## SERVICE BULLETIN

**SB-080323-B**

**ID NUMBER & REVISION:** SB-080323-B  
**SUBJECT:** Nose Landing Gear Limit Switch Retrofit  
**RELEASE DATE:** 20 November 2023  
**EFFECTIVE DATE:** 20 November 2023  
**SUPERSEDES NOTICE:** SB-080323-A  
**AIRCRAFT AFFECTED:** **MAKE & MODEL:** ICON A5  
**SERIAL NUMBERS:** 00001-00015, 00018-00033, 00035-00036, 00038-00072, 00074-00086, 00088-00182, 00184-00188

Figure 1. Bracket Modifications for 10-32 Studs

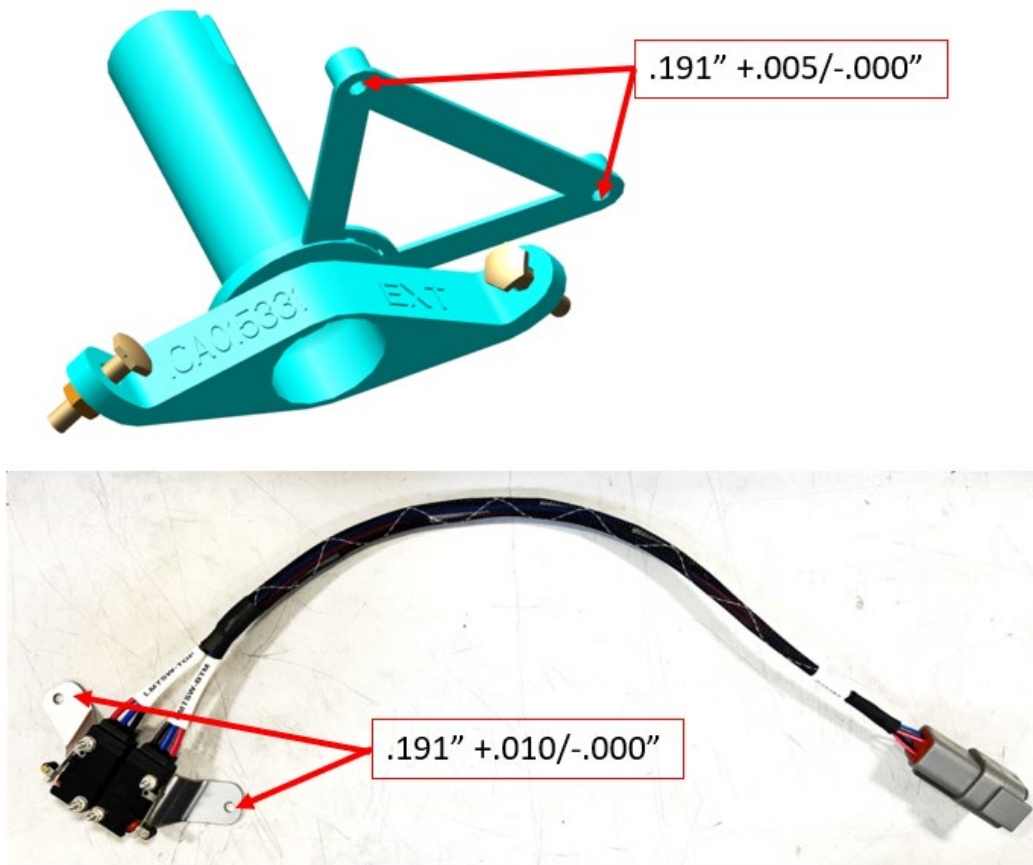
If using either kit with 10-32 studs (ME001168 or ME001188), complete the following bracket and tool modifications. (If using 8-32 studs, continue to INSTRUCTIONS.)

1. Drill the 2x holes in the Limit Switch Bracket Fixture (part of ME001175) to .191" +.005/-.000".
2. Drill the 2x holes in the Limit Switch Subassy Bracket (ME001143 or part of ME001168) to .191" +.010/-.000".
